PREPARED FOR THE PLAN COMMISSION

Plan Title: University Avenue Corridor Plan: Blending the Past, Present and Future

Prepared By: Planning Division Staff (Report Includes Comments from City Boards, Commissions, and Committees)

Figure 2: Draft Corridor Plan – Recommended Changes to the Comprehensive Plan

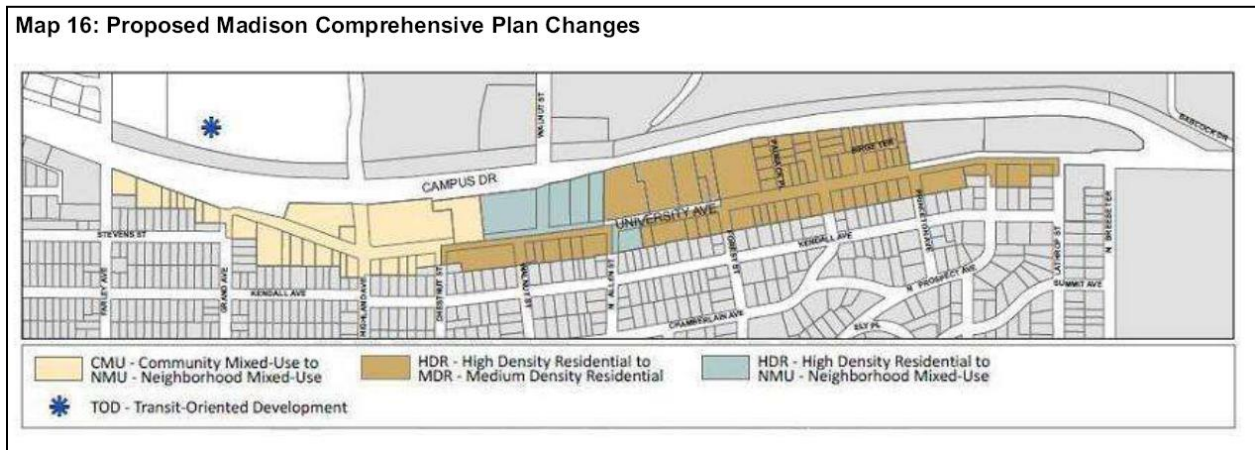
Staff generally supports the changes recommended in the University Avenue Corridor Plan for land use designations along the south side of University Avenue (west of Chestnut along the south side, a change from CMU to NMU; and east of Chestnut, a change from HDR to MDR). These changes would likely result in the maintenance of residential densities along the south side of the corridor similar to what exists today, while still allowing for some redevelopment.

Figure 4: Planning Staff Response to Draft Corridor Plan Land Use Recommendations

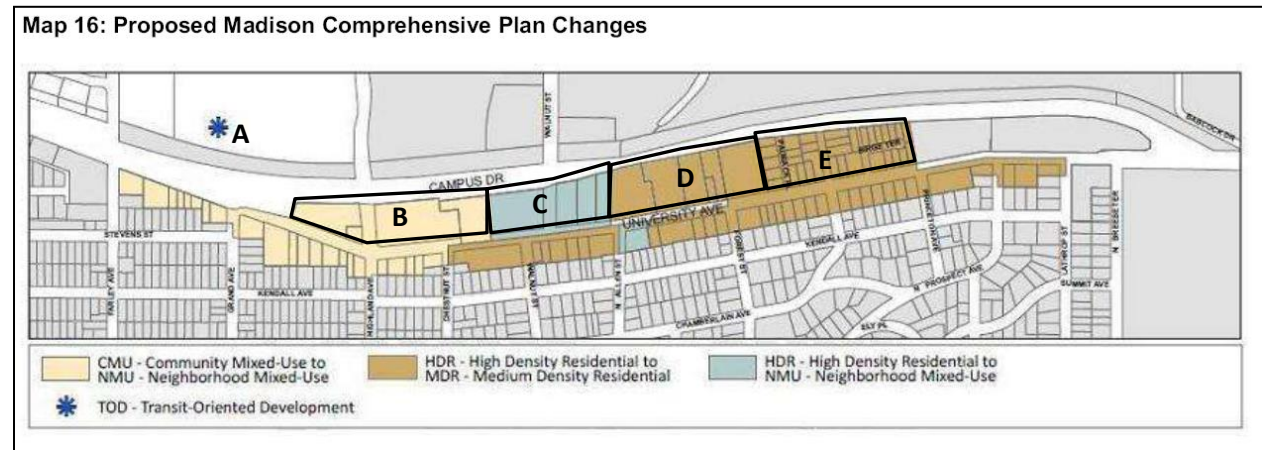
However, staff recommends several changes to the Draft Corridor Plan’s proposed land use designations along the north side of the corridor. The staff recommended changes are explained for the sub-areas identified by the letters A through E in Figure 4.

- A. In the draft Plan, the Transit-Oriented Development (TOD) node designation located within the corridor generally between Highland and Walnut has been relocated outside of the Planning Area northwest of Campus Drive. Staff recommends that this symbol be moved back to its original location, in the area bounded by Campus Drive, University Avenue, Highland Avenue and Walnut Street, as shown in the Comprehensive Plan. The University Avenue/Campus Drive corridor is envisioned as a major transportation and transit corridor, and while the boundaries for a future TOD node are not precisely defined, location within this existing and planned future mixed-use and residential development area seems most appropriate.

- B. Staff considers the recommended change in the mixed-use designation from CMU to NMU essentially neutral since the types of intended uses and height and design parameters are defined more precisely within the Corridor Plan in any case. It is appreciated that NMU may more closely reflect the neighborhood vision for the area. Staff can support the recommendation to change the land use designation from CMU (Community Mixed-Use) to NMU (Neighborhood Mixed-Use) in Area B, but only with an additional recommendation supporting high-density residential uses, in either mixed-use or purely residential buildings. This area currently includes the following uses:

The net residential density of the area today (dwelling units per acre on properties with dwelling units) is 108 units per acre, and lots are approximately 220 feet deep. Staff would support residential densities exceeding 100 units per acre in this area, so long as buildings maintain a strong relationship with the street, and provide a range of dwelling unit types, and the infrastructure and amenities to support this density. Staff notes that the design recommendations in the draft Plan (pp. 72-76) regarding articulation, rhythm, and multiple entrances for buildings exceeding 80 feet in width are excellent recommendations to guide redevelopment in this area.

- C. Similarly, staff can support the recommendation to change the land use designation from HDR (High Density Residential) to NMU (Neighborhood Mixed-Use) in Area C, but only with the assumption that high-density residential uses will be supported within either mixed-use or purely residential redevelopment. Staff notes that, with some commercial spaces in the corridor already struggling, it is not necessary to see this area developed with mixed-use buildings (although some ground floor commercial space would be fine), and both mixed-use buildings and purely residential buildings can be supported. The area currently includes the following uses:

The net residential density of the area today (dwelling units per acre on properties with dwelling units) is 80 units per acre, and the lots are approximately 220 feet deep. Again, staff would support residential densities exceeding 100 units per acre in this area.

- D. Staff does not support the recommendation to change the land use designation in Area D from HDR (High Density Residential) to MDR (Medium Density Residential), a recommendation that would mean that future residential densities supported by the plan would be only approximately half the existing density. The area currently includes apartment buildings ranging from 3 to 5 stories in height as follows:

The current net residential density in this area is 76 units per acre, and the area includes a large amount of surface parking that could support additional development in the future. As the existing buildings continue to age, the area may become attractive for more efficient, coordinated redevelopment with structured parking and a wider range of dwelling units to support a variety of household types. Staff would support residential densities exceeding 80 units per acre in Area D.

- E. Staff does not support the recommendation to change the land use designation in Area E from HDR (High Density Residential) to MDR (Medium Density Residential), but recommends that this unique area remain at a similar density as exists today. Most properties in this area are very small lots with two-story residential buildings in varying states of repair. While redevelopment of the area would be supported by staff, maintenance of the existing lot pattern and rhythm of buildings is recommended. Staff recommends that a maximum residential density of 50 dwelling units per acre for this area be specified on a revised Future Land Use Map. This density is close to the existing density, but should still provide opportunities for lot by lot redevelopment in small buildings up to three stories which could include a broader variety of unit types. The Plan should specifically recommend that the “small-lot” rhythm be retained.

1. Revise Map 16, “Proposed Madison Comprehensive Plan Changes” and associated narrative in the Plan as follows:
 - a) Return the transit oriented development node to its original location between Campus Drive, University Avenue, Highland, and Walnut.

- b) For areas B and C shown on Page 5 of this report, which are recommended for the land use designation of “NMU (Neighborhood Mixed Use), indicate that residential densities exceeding 100 units per acre are supported.

- c) Maintain the HDR (High-Density Residential) land use designation for areas D and E, noting for area D that densities of 80 units per acre or above are supported, and for area E that densities of up to 50 units per acre are supported.

Figure 5: Draft Corridor Plan Recommendations for Building Height

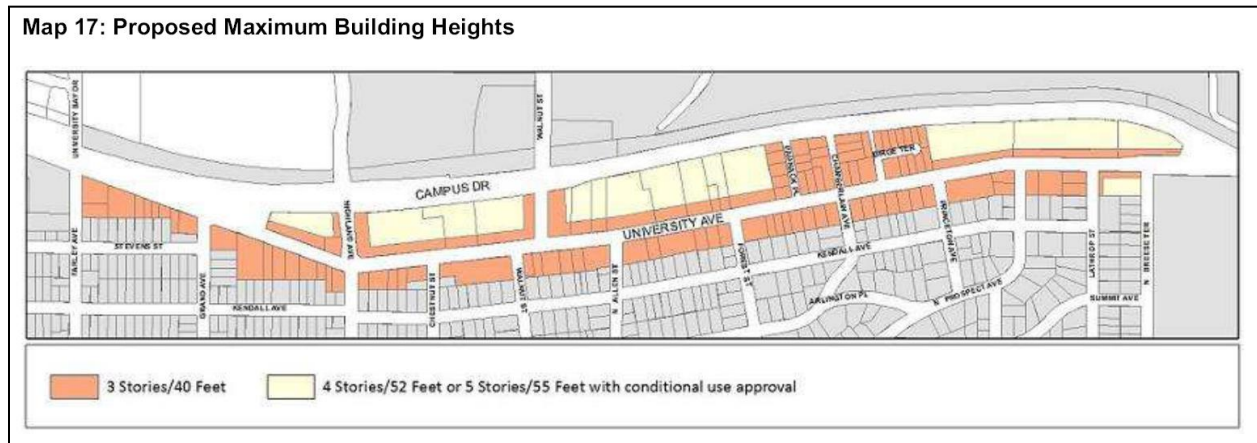
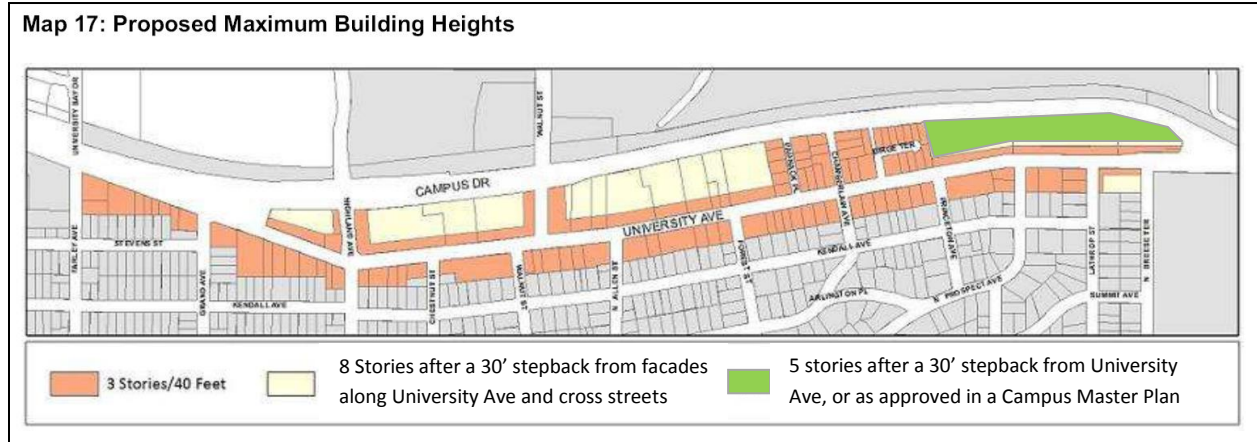
However, staff does not support the recommended four to five story maximum height on the deep properties bounded by University Avenue and Campus Drive. Although not a substantive issue, staff notes that Map 17 suggests that a conditional use requirement can be triggered by the Plan recommendation itself. Instead, conditional use thresholds are established in the zoning code. This area is currently zoned TSS, TR-U1, and TR-U2. Conditional uses will be required in the TSS District for any building over three stories, and in the TR-U1 and TR-U2 District, for any building with over 8 residential units. Thus, the vast majority of redevelopment proposals will likely require conditional use review in any case.

Staff believes that with a three-story height limit on the University Avenue facade, these properties could support heights up to six to eight stories with a sufficient stepback from the facade. This is an area very appropriate for greater densities, as discussed above, and additional building height is not likely to have shadow or “canyonization impacts” on the residential neighborhood to the south, so long as it is stepped back from University Avenue.

Staff also recommends that the Plan set a 5-story maximum height limit as allowed in the TR-U1 Zoning District for the University of Wisconsin owned properties in the northeast corner of the Planning Area.

However, staff recommends that the Plan acknowledge that a future Campus Master Plan that may seek taller heights, and if approved by the Common Council that this Plan should be amended to reflect that decision.

To incorporate these changes, staff recommends that Map 17 be revised as shown in Figure 6 below:

2. Revise Map 17, “Proposed Maximum Building Heights”, as shown in Figure 6 on Page 9 of this report, and change associated narrative in the Plan.
3. Eliminate Map 18, “Proposed Minimum Front and Rear Yard Setbacks”, and eliminate any narrative in the Plan pertaining to rear yards differing from the underlying zoning requirements. Provide narrative in the Plan recommending that in areas where front setbacks are not required by underlying zoning, a 5-foot front setback should be provided to create space for streetscape amenities in front of commercial uses and for landscaping in front of ground floor residential uses.

Figure 7: Draft Corridor Plan Recommendations for Building Setbacks

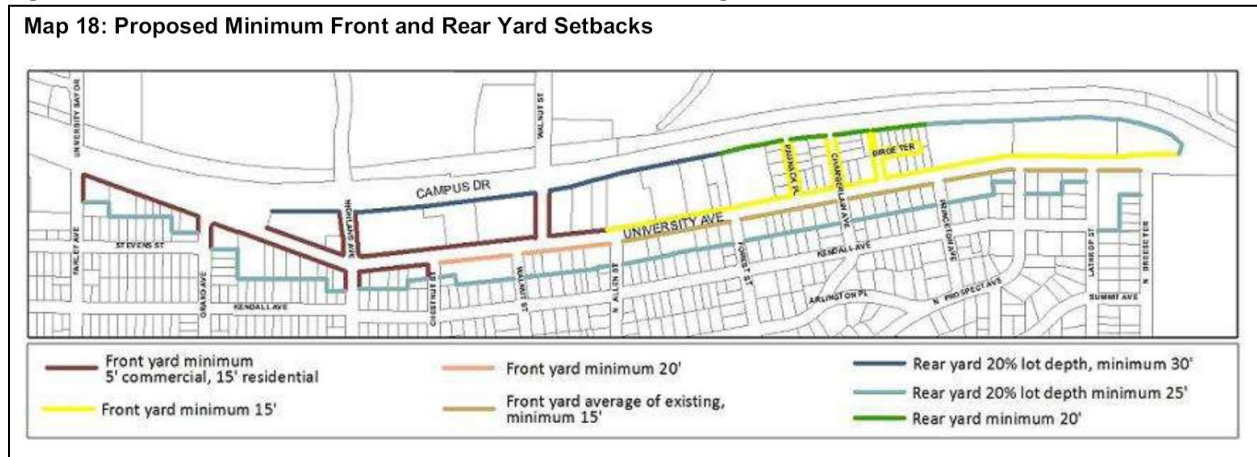
In general, staff considers the setbacks established by the zoning districts to be appropriate, and recommends that many of the different setback recommendations in the draft plan be eliminated or revised, as described in detail below.

Staff recommends eliminating all of the rear yard setback recommendations and deferring to underlying zoning requirements, which generally range from 20 to 25 feet for the zoning districts in the area, but could be as low 20%-25% of the lot depth, which would lead to lesser rear yard requirements on lots under 100 feet deep. Staff does not believe that it makes sense to create deep rear yard setbacks along Campus Drive (the Plan effectively recommends rear yards greater than 40 feet, when taking into

account the 200+ foot deep lots in this area), but would rather see development as close to Campus Drive as the rear yard requirement in the base zoning district would allow. This is an area that will have few if any impacts on area residents, and deeper setbacks would not necessarily result in quality usable open spaces abutting Campus Drive.

With regard to the front yard setbacks recommended in the Plan, staff notes that the 15-foot recommended front yard setbacks on both sides of University Avenue east of North Allen Street is consistent with the requirement in the underlying TR-U1 and TR-U2 Zoning districts, and is thus unnecessary to include in the Plan. Staff does not support the 20-foot setback recommended just west of North Allen Street on the south side. This is greater than the 15-foot setback required in the underlying TR-U1 zoning district, and also greater than the existing 15-foot setback of most of the buildings along this stretch. Staff believes that this can also be eliminated from the Plan.

Staff could support the recommended 5-foot front yard setback for commercial and mixed-use buildings on both sides of University Avenue and the cross streets in the western portion of the corridor, although it is important to note that the underlying TSS (Traditional Shopping Street) zoning district in this area does not require a front yard setback. Staff notes that since some of these lots are relatively shallow, the provision of a front yard setback will likely push buildings back further toward the rear property line than they might otherwise be, but the rear yard setback would apply in any case. If this recommended 5-foot setback is maintained, staff strongly recommends that it pertain to all building types, rather than having the deeper 15-foot setback requirement for residential buildings. This will allow for a consistent street frontage, regardless of ground floor use, while still allowing for a variety of treatments between the building and the sidewalk (structured landscaped areas between the sidewalk and residential buildings, and hardscaped areas to accommodate benches, bicycle parking, etc. in front of commercial or mixed-use buildings).
